**SSD 9835 Sydney Football Stadium Redevelopment – Condition B8(d)
detailed design of the south eastern corner**

John Holland Group
Sydney Fitness Facility
Aeroacoustic wind report

Rel.01 | 7 May 2021

Figure 6: Cladding elements with horizontal slot

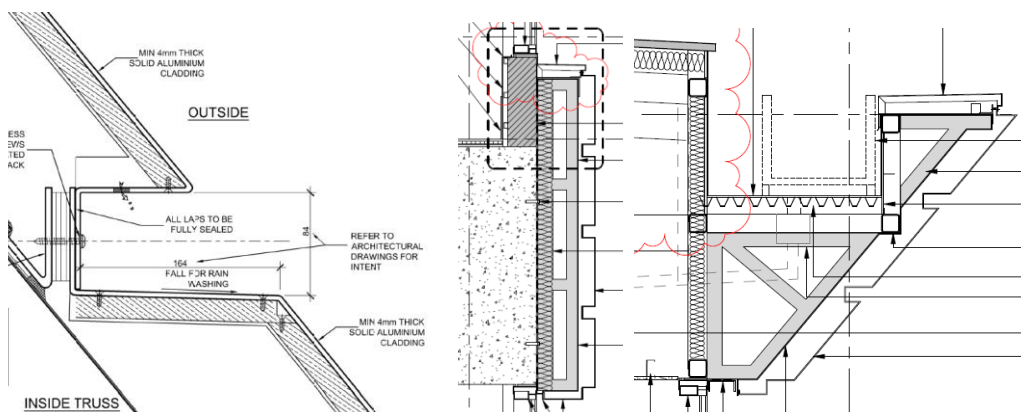
The horizontal slots wrapping around the façade, Figure 5 and Figure 6, have the potential to act as a **resonator**. To activate this mechanism, the flow generally has to be perpendicular to the length of the slot. Since the slots are horizontal and the flow would not be vertical along the length of the slots, the potential for aeroacoustic noise is expected to be low.

Figure 7: Sunshades and mechanical louvres

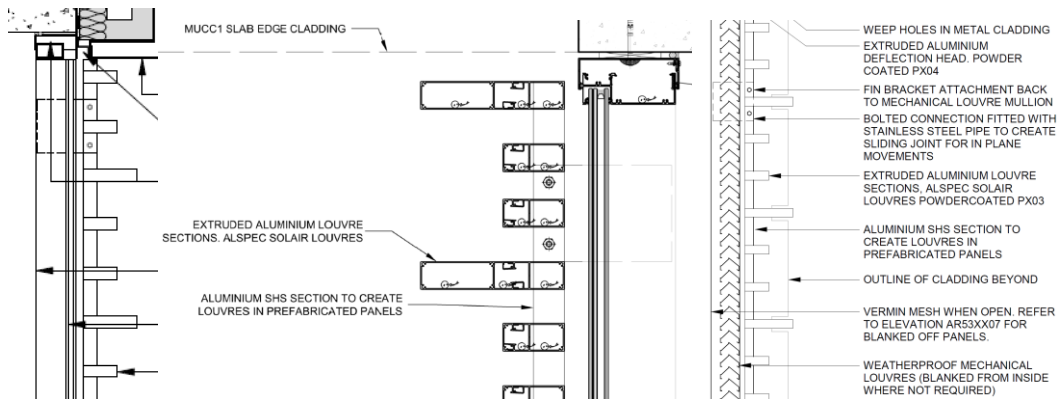
External sunshade elements are located around the facades, either in front of a solid façade or open weatherproof louvres, Figure 7. There is the potential for

parallel plate pressure noise through the solar louvres or V-shaped louvres, but not when there is a solid surface behind.

For the sunshade elements with a solid structure behind, the flow mechanism would not produce aeroacoustic noise. There is a greater potential when there is flow through the sunshades and louvres. As the louvres generally open into an enclosed plant room, there is a limited flow path and the flow through the louvres would be primarily be governed by the plant. This is highly unlikely to cause any aeroacoustic issues. The only location where there is potential for increased wind speed is in the north-west corner, where the plant room is open to the north and west, Figure 8. The relative orientation and proximity of the louvres and sunshade elements would be expected to significantly reduce the potential for aeroacoustic noise by disrupting any pressure propagation. The risk of this mechanism producing noise is consider low.

Figure 9: Perforated aluminium panels

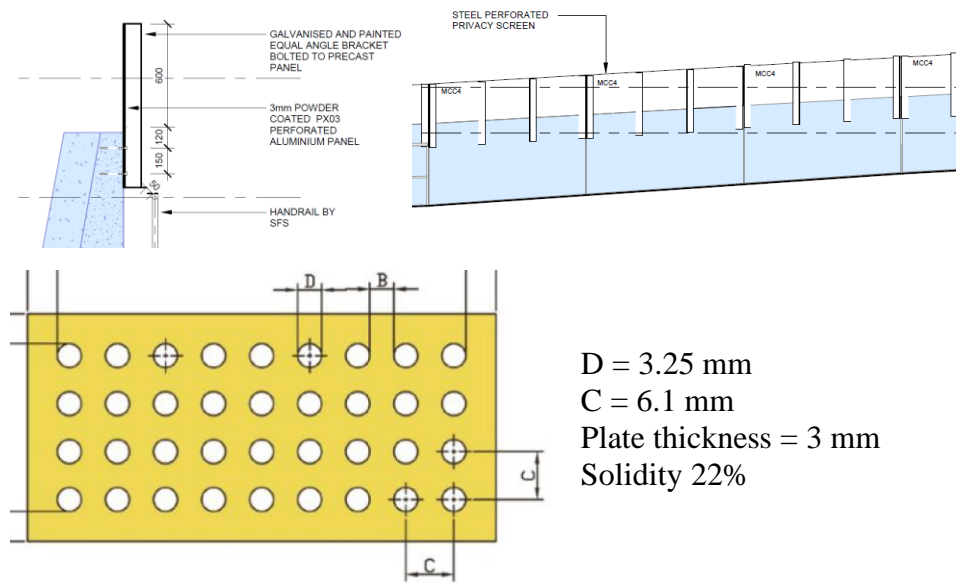
The **perforated** aluminium panels on top of the walkway ramp balustrades have the potential to produce noise, Figure 9. The current size and regularity of the holes are presented in Figure 9. From previous testing, the ratio of hole diameter to plate thickness is in the range when aeroacoustic noise could occur. The uniform circular hole pattern is the most susceptible pattern to induce aeroacoustic noise over a range of incident wind directions. This design would cause a moderate risk of aeroacoustic noise generation. Thickening the plate to 5 mm, varying the diameter or shape of the hole, and/or varying the hole pattern across the plate would reduce the potential for aeroacoustic noise.

We confirm that the thickness of the sheet and the hole size have been designed in accordance with the original design intent, with a perforation hole size and setting out responding to the required acoustic requirements.

I read the Cox letter and am assuming that their last paragraph means that they have varied both the hole size and pattern as suggested in the Arup report.

So, I support the design change on the basis that it is an improvement on the previous design.
